New Albany Architectural Review Board Meeting Agenda
Monday, June 8, 2026, 7:00 p.m.

New Albany Architectural Review Board
Monday, May 11, 2026 Meeting Minutes - DRAFT

**6600 NEW ALBANY-CONDIT ROAD OFFICE
FINAL DEVELOPMENT PLAN**

Image: Proposed monument sign.

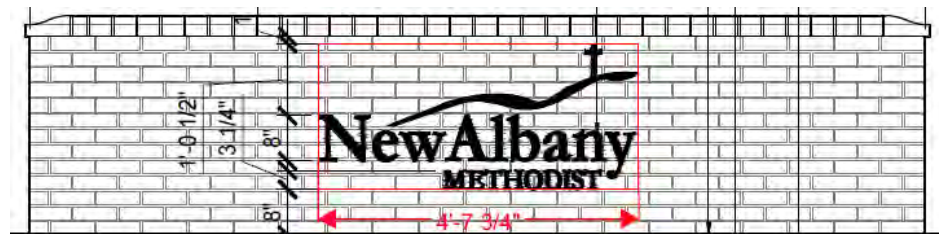
- C.O. 1169.17(c) does not permit monument signs in the Campus sub-district of the Village Center. The applicant is requesting a waiver to allow the monument sign. For other sub-districts and use categories, the city sign code has the following requirements:

- The relief and lighting have not been specified in the plans. Staff recommends a condition of approval that the dual-post sign have a minimum relief of one inch and not be illuminated, subject to staff approval (condition #1).

Approved

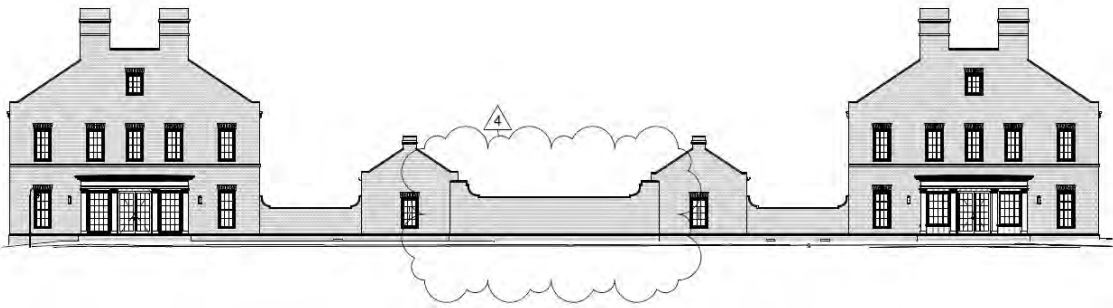
- The applicant proposes redesigning the brick wall along Main Street by eliminating the window well cutout, light fixtures along the brick wall, and altering the cap details.

- The brick wall is now proposed to feature a blank façade with a consistent height along Main Street between the two units. The previous design of the brick retaining wall was approved with a condition that states, “Guardrails at the window wells and iron work on the center Main Street retaining wall shall be subject to staff approval if required.” Since the new design proposal does not include these specific details as part of the condition of approval from ARB-106-2023, the application has come back to ARB for approval of the changes.

- The applicant has proposed to remove light fixtures, a window well cutout, and the proposed metal railing that were part of the previously approved brick wall.

Image: Proposed site layout, showing the buildings, pavement and parking, and general landscaping.

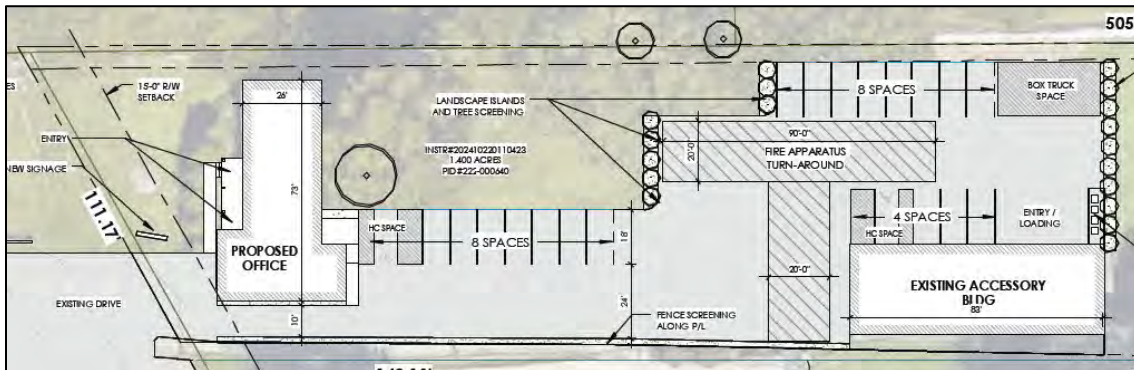
6. A Traffic Access Study will be completed for Planning Commission review.
7. As required for commercial developments by the Urban Center Code (see UCC evaluation below), staff recommends a condition of approval that a bike rack be installed on the site, subject to staff approval (condition #2).

Image: Proposed exterior of main building.

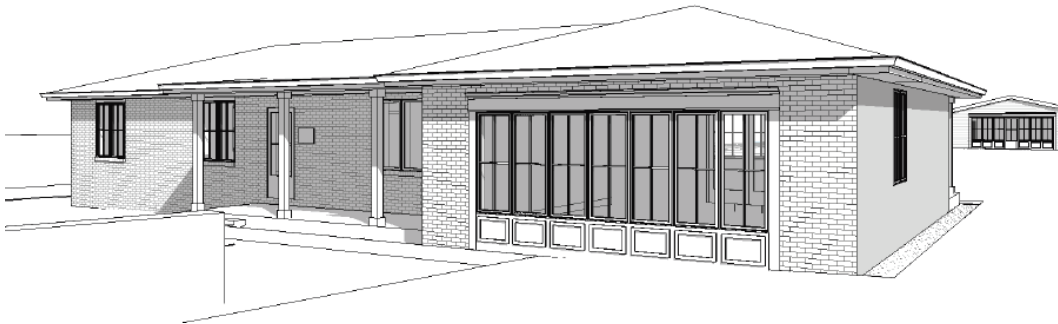
3. The renovations proposed in the final development plan are generally aligned with applicable sections of the DGRs. The main renovations proposed by the final development plan include:

- o The existing exteriors of both buildings will be painted.
 - o The essential character and structure of both buildings will remain.

Image: Axonometric sketch from the City Architect depicting the proposed garage relative to the main entry mass.

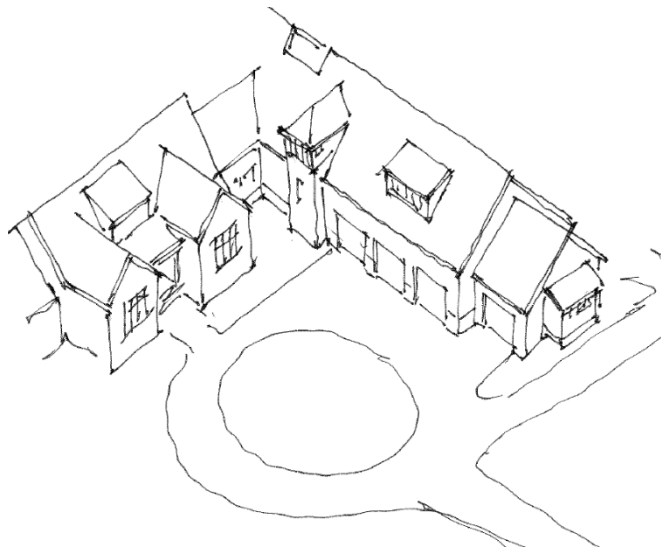
- The applicant proposes a new home with a large garage mass extending approximately 55 feet from the main portion of the home toward the public right-of-way. The garage mass includes four garage doors that face the eastern side yard and are not front facing, though they are in front of the main portion of the house. The garage mass appears to be approximately 30 feet in height and is one of only a few portions of the house with a second-story dwelling area.
- DGR Section 1(I)(E) states that parking areas and garages should be placed in locations to minimize their visual impact through a combination of garage location and landscaping or other screening methods. It further states that garage doors should not be on primary façades

of buildings. Similarly, the Engage New Albany Strategic Plan encourages rear or side-loaded garages, and when a garage faces the street, the front façade of the garage should be set back from the front façade of the house (Engage New Albany, p. 60).

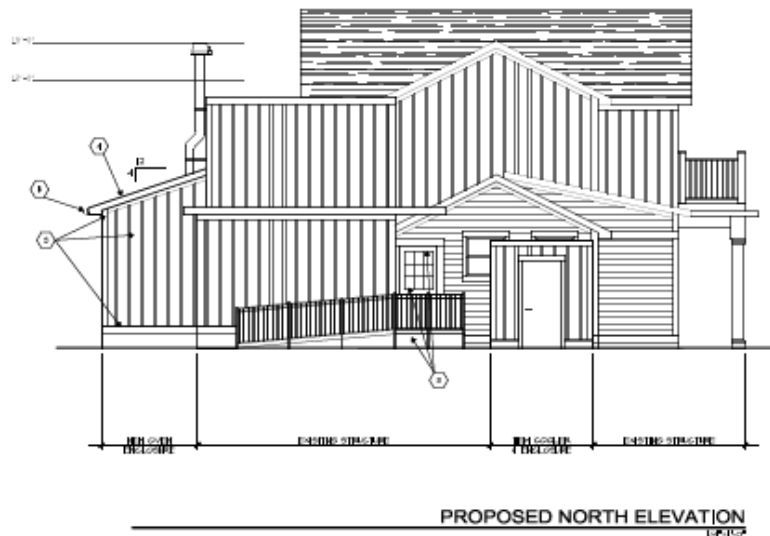
- The oven enclosure is proposed to include a ventilated pipe that extends slightly below the highest point of the primary structure's roofline. In addition to the oven enclosure, the applicant proposes relocating the patio ingress/egress slightly to the east to accommodate the addition.

- The cooler enclosure is proposed to be detached and located next to the existing ramp on the north side of the building, and will have the same building materials as the existing structure on site.
